Project: 21-501 - Collin County Adult Detention Facility, Phase 1 Addition
4300 Community Avenue
McKinney, Texas 75071

Prime Contract Potential Change Order #019: PR #5 Storm Revisions

PROPOSAL REQUEST **05**

Item No. 1. Provide pricing for the revised Storm line due to the Pier/RCP incident on 7-20-2022. The Work associated with this change has already been completed. This PR is being issued to capture the cost and re-issue the formal drawings associated with this issue.

DEMOLITION PLAN

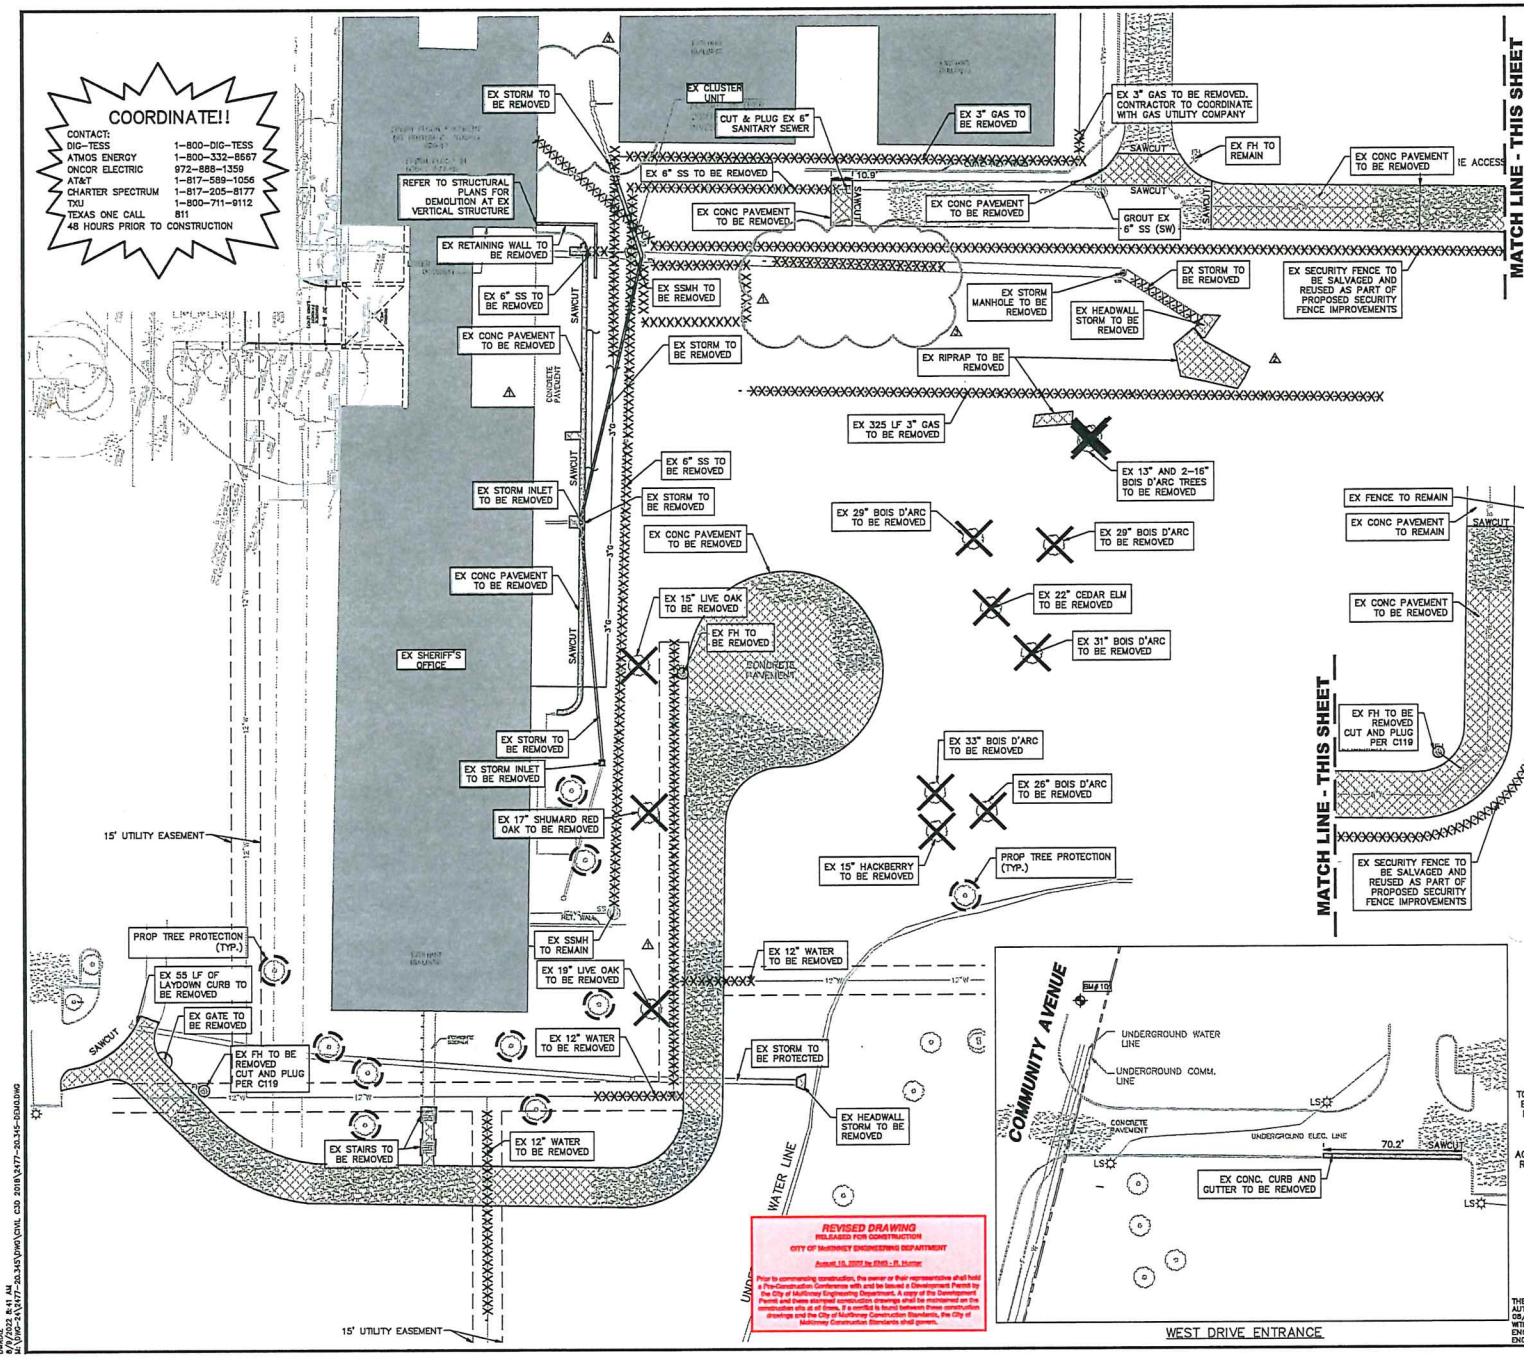
Provide for additional work required to complete all work associated with PR#5 dated 8/12/22. This includes ADDED 48" RCP III per sheets C100, C112, C113, and C118.1. In addition, pricing is included to chip off excess concrete for piers that were poured in the existing RCP per JQ field report dated 8/3/22.

NO.	DATE	REVISION
3	08/03/2022	PR-4 & PR-5 FIELD STORM MODIFICATION
2	06/23/2022	RFI#44
1	04/28/2022	RFI#39

STORM SEWER PLAN
COLLIN COUNTY ADF - PHASE 1 ADDITION
COLLIN COUNTY JUSTICE CENTER
4300 COMMUNITY AVENUE
CITY OF MCKINNEY, COLLIN COUNTY, TEXAS

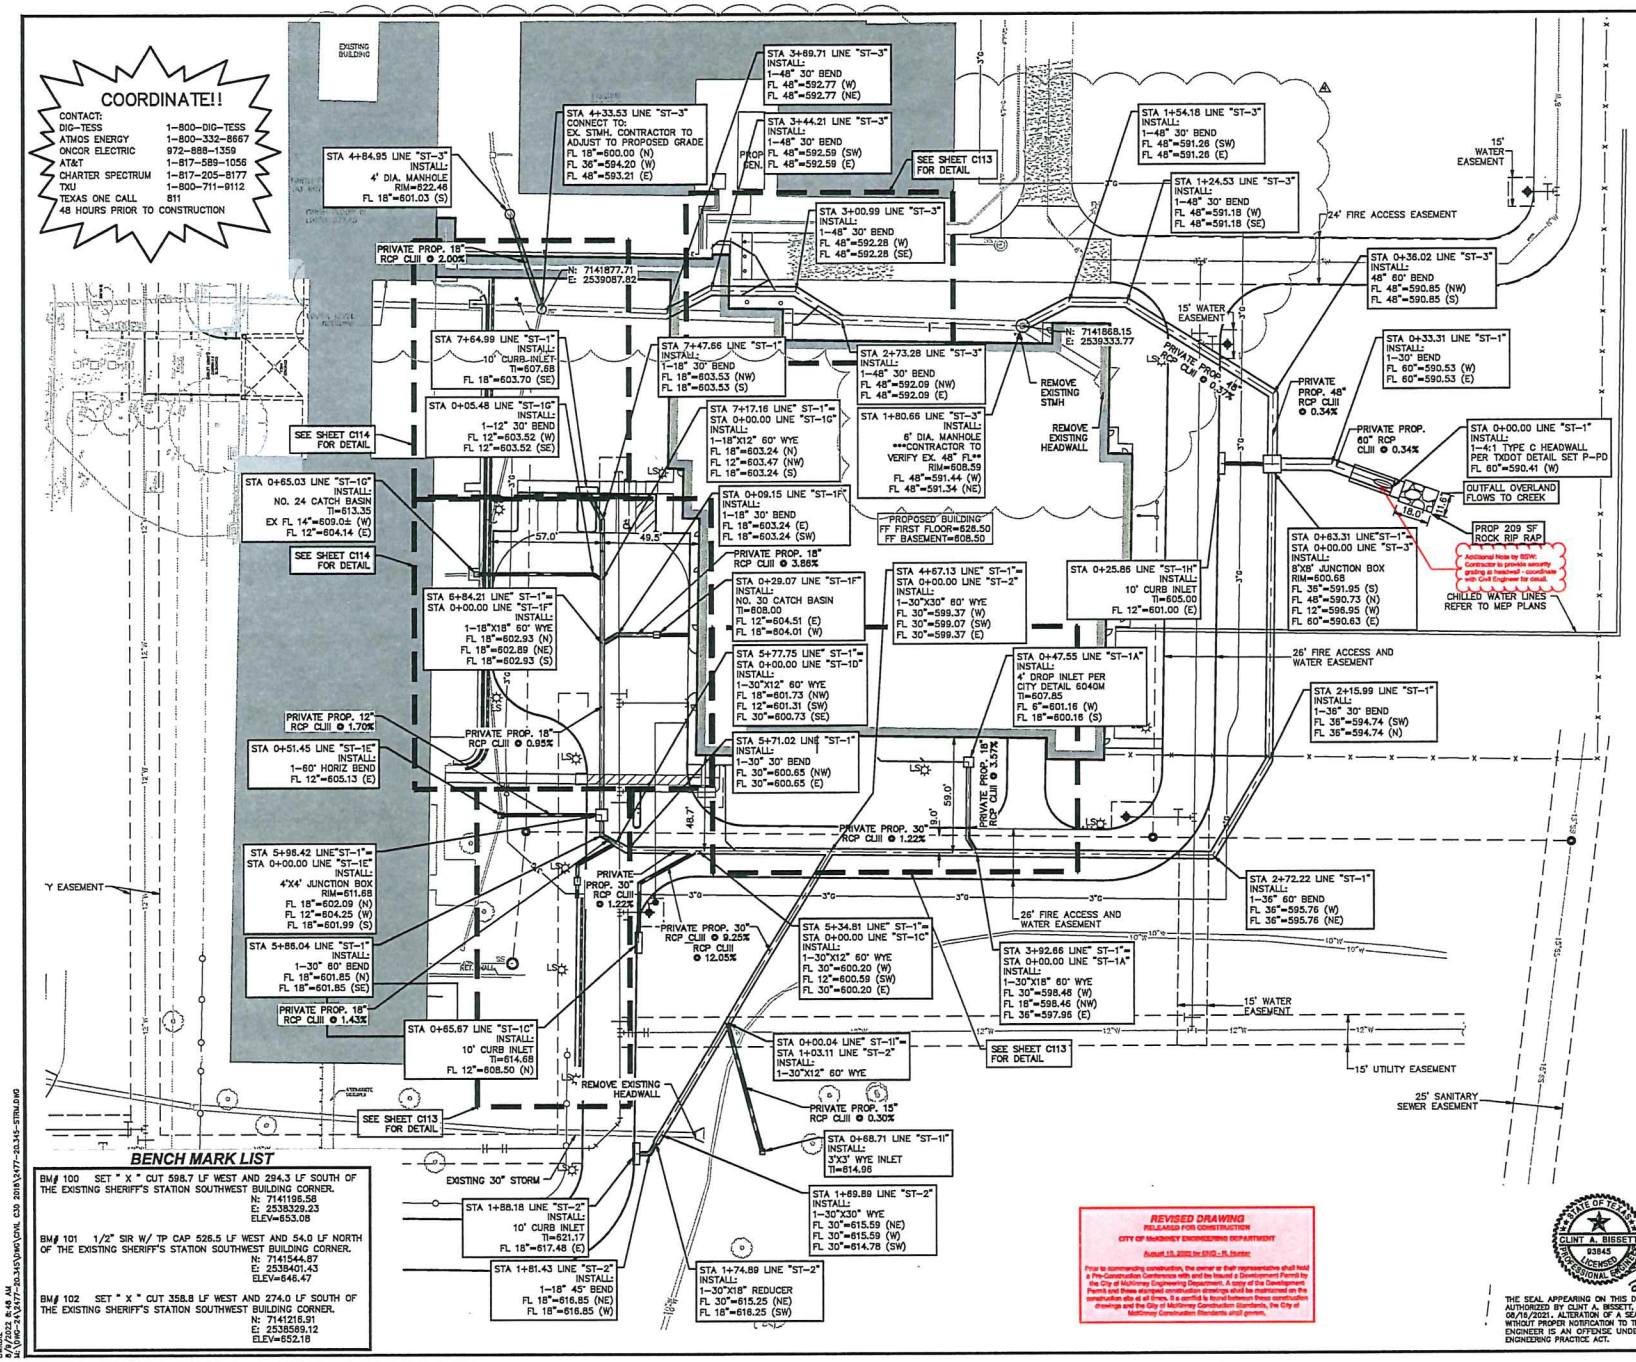
Item	Description	Quantity		Pricing	Total
	****RFI#44 C112 ADDED STORM****				
1	48" CLASS 3 RCP	72	LF	$151.00	$10,872.00
	****LABOR ****		EA		
2	5 MAN CREW PER DAY	5	EA	$1,441.00	$7,205.00
	****EQUIPMENT****		EA		
3	EXCAVATOR (1 WEEK)	1	EA	$1,750.00	$1,750.00
4	FRONT LOADER (1 WEEK)	1	EA	$937.50	$937.50
5	COMPACTION ROLLER (1 WEEK)	1	EA	$500.00	$500.00
	****OH&P****				
6	OH & P (10%)	1	EA	$21,264.50	$2,126.45

NO.	DATE	REVISION
4	08/03/2022	PR-4 & PR-5 FIELD STORM MODIFICATION
3	07/18/2022	RS1#44 WITH CITY COMMENTS
2	01/21/2022	2022-01-07 CITY COMMENTS
1	10/19/2021	2021-09-22 CITY COMMENTS

Photograph 2 – Pier

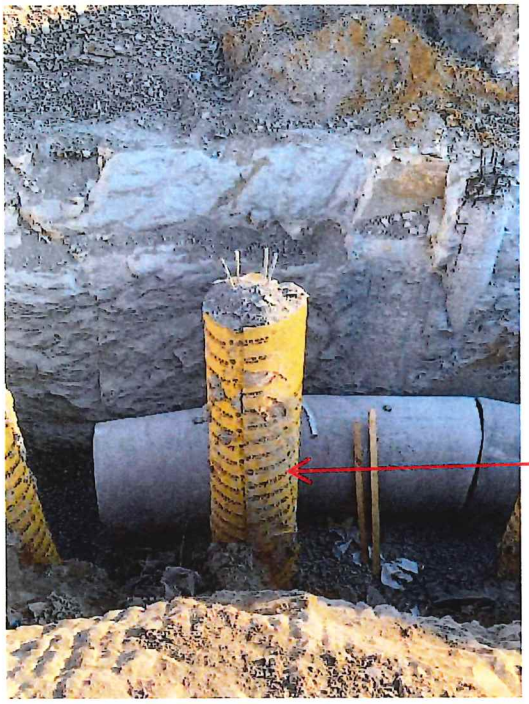
1. **Sonotubes:** Sonotubes were installed during pier installation to ensure concrete did not seep out into the pipe. See **Photograph 2, 3, and 4.**

REMOVE SONOTUBE BEFORE BACKFILLING THE SOIL

Comment: *JQ suggests removing all of the sonotube material before backfilling the soils around the pier.*

Photograph 3– Pier

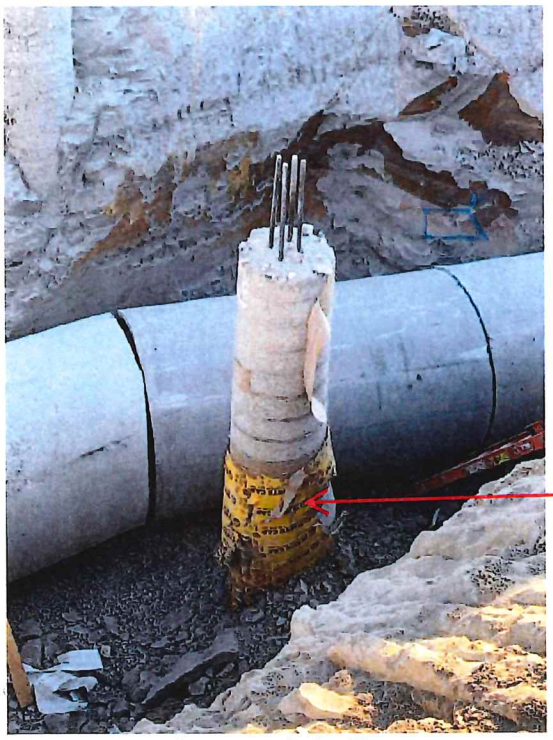
REMOVE SONOTUBE BEFORE BACKFILLING THE SOIL

Photograph 4– Pier

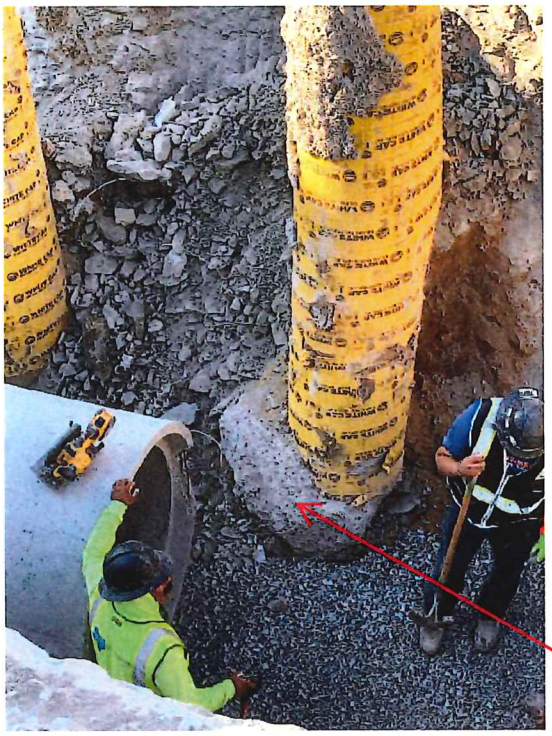
CHIP OUT CONCRETE AS STATED IN THE REPORT

Photograph 5– Excess Concrete Below Sonotube

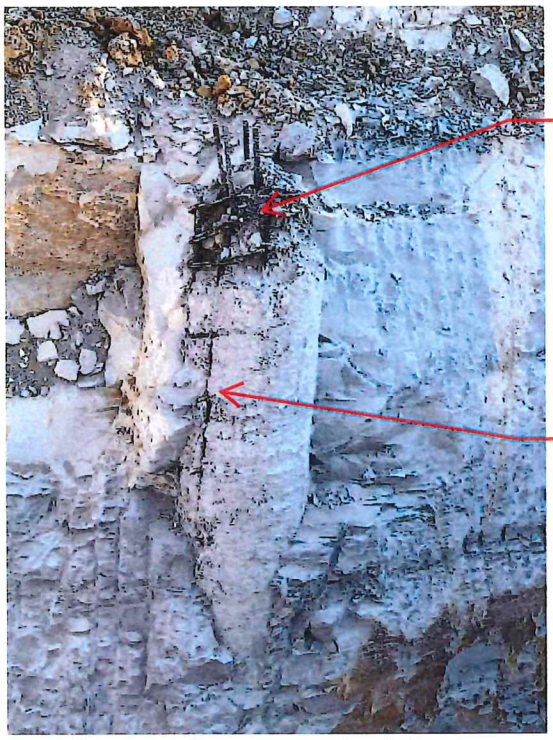
2. **Extra Concrete below Sonotube:** At one pier location it appears that the sonotube was not installed far enough into the soil below so there is some extra concrete that spilled out during the concrete pour. See **Photograph 5**.

PIER TO BE REPAIRED TO THE PROPER TOP OF PIER ELEVATION

PIER TO BE REPAIRED PER THE ATTACHED DETAIL

Comment: *All excess concrete shall be chipped out around the pier so that it has the diameter shown in the contract documents. Care shall be taken to not damage the pier of the reinforcing.*

Photograph 6– Exposed Reinforcing

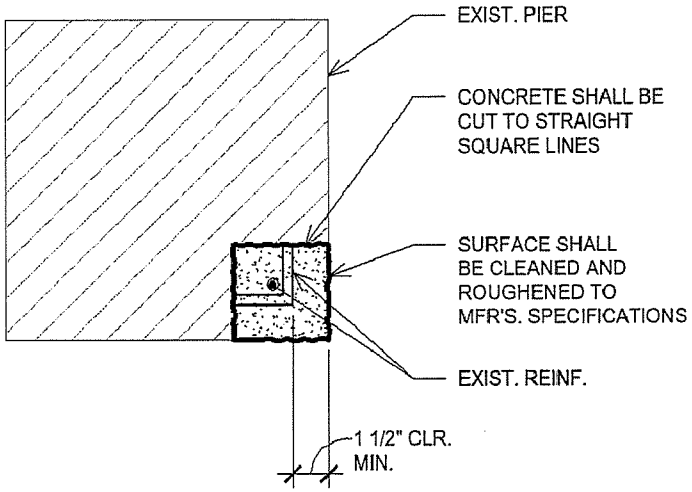
4. **Exposed Pier Reinforcing:** One pier was observed to have exposed reinforcing on the side of the concrete. Concrete around the reinforcing does not appear to be properly consolidated. Concrete also does not appear to have been fully poured to the top of pier elevation. See **Photograph 6.**

COLUMN REPAIR WITH EXPOSED REINFORCING

Comment: *Contractor shall chip out all un-sound concrete and repair the pier per the attached detail. Pier shall be poured up to the proper top of pier elevation per the contract documents.*

1. CONCRETE REPAIR MORTAR SHALL BE EQUAL TO "SIKATOP 123" NON-SAG MORTAR BY THE SIKA CORPORATION.
2. ALL SURFACES TO WHICH CONCRETE REPAIR MORTAR IS TO BE APPLIED SHALL HAVE ALL LOOSE AND UNSOUND MATERIAL REMOVED. SURFACE PREPARATION SHALL BE IN ACCORDANCE TO THE MANUFACTURER'S RECOMMENDATIONS. WIREBRUSH, POWER TOOL BRUSH, OR SANDBLAST ANT EXPOSED RUSTED REINFORCING STEEL TO REMOVE LOOSE RUST.

3. AT PERIMETER OF AREA TO BE REPAIRED, CHIP OUT EXISTING CONCRETE TO A MINIMUM DEPTH OF 3/8". DO NOT FEATHER REPAIR MORTAR AT EDGES
4. COMPLY WITH ALL HANDLING, MIXING, PLACING AND CURING REQUIREMENTS AS SPECIFIED BY THE REPAIR MORTAR MANUFACTURER.

5. APPLY SCRUB COAT OF REPAIR MORTAR TO SATURATED SURFACE DRY CONCRETE IN ACCORDANCE TO PRODUCT SPECIFICATIONS.
6. PRIME REINFORCING STEEL WITH "SIKA ARMATEC 110" BONDING AGENT IN ACCORDANCE TO MANUFACTURER'S INSTRUCTIONS.

7. FINISH REPAIR MORTAR TEXTURE TO MATCH TEXTURE OF SURROUNDING CONCRETE
